# NORTH WITNEY HOUSING DEVELOPMENT

# **Challenges and Interventions**

(Issue 3 – Feb 2025)

Issued as a response to planning application 24/00482/OUT and as a consultation document with local councils that support WING.

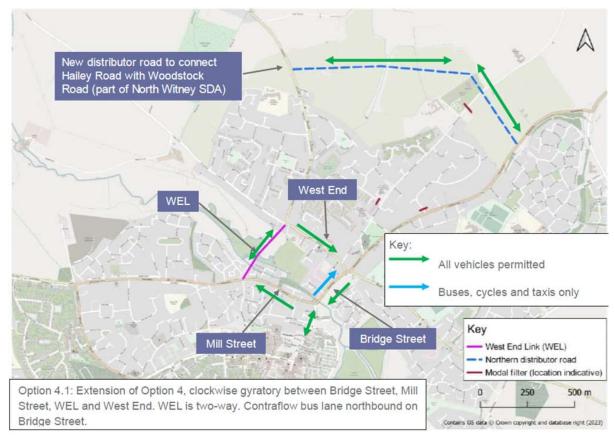
The developers applying to build the North Witney housing estate have omitted the WEL, citing Oxfordshire's Local Transport and Connectivity Plan 2022-2050 [4], which discourages the construction of new roads unless necessary.

The impacts of building 1400 houses *without* a second river crossing are likely to include:

- Increased congestion on West End, Bridge Street, Woodstock Road and Newlands into and out of Witney, described as 'Carmageddon' in the Oxford Mail.
- Increased NO<sub>2</sub> levels and concomitant particulate pollution on Bridge Street, the Air Quality Management Area which has an Air Quality Action Plan [10], [11], that cites the WEL as part of the measures expected to bring Bridge Street air quality up and NO<sub>2</sub> levels down to compliance with national objectives.
- A missed opportunity to dovetail flood mitigation measures at the river.
- A missed opportunity to improve walking and cycling routes to connect residents to Witney.

WING takes the position, consistent with the WODC Local Plan 2031 and OCC's Local Transport Connectivity Plan 2022, that the WEL must be a prerequisite of the development going ahead. This might take the form of a planning condition or a reason for refusal of the plans in their current form.

#### **Proposed arrangement**

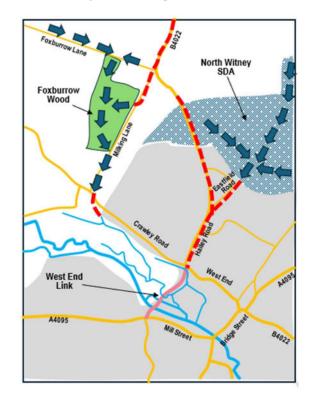
The 750mm diameter drain from the junction of Eastfield Road with Hailey Road down to the outfall into the basin area above Bridge Street is the focus for this table. Currently this length of piped drain becomes overloaded in periods of severe rainfall and overflows from the manholes onto the road surface. The outfall from the drain into the basin is also restricted because the basin is in flood. Consequently, more water backs up in the drain. The roundabout at the bottom of Hailey Road becomes flooded and impassable.

Intervention Number	Description	Outcome/Comment
	Interventions downstrea	m of Hailey Road Drain
HR1	Clear the obstructions and flooding issues downstream of Hailey Road to ensure there is a clear outfall into the basin.	of the Bridge Street interventions 1-6 as listed in the

Intervention Number	Description	Outcome/Comment
	Interventions at Hailey Road Drain	
HR2	Consider measures to increase the capacity of the drain.	A complete reconstruction of this drain would be expensive and extremely disruptive. WING's proposal is that this action could not be justified.
Interventions upstream of Hailey Road Drain		
HR3 (linked to Bridge St Intervention No.7)	Reduce the peak flow entering the Hailey Road drain from North Witney housing area by constructing attenuation ponds in the development area.	A series of small attenuation ponds is indicated in the developer's proposals for North Witney housing. Although these may be adequate to limit the flow rate from the housing development into the existing piped drainage system and prevent an increase in flow, these proposals will not overcome the current flooding problems in the Hailey Road drain. Providing fewer, larger ponds to increase capacity would reduce flood risks for Witney. The current drainage arrangement floods during severe weather events. An element of improvement is therefore essential.
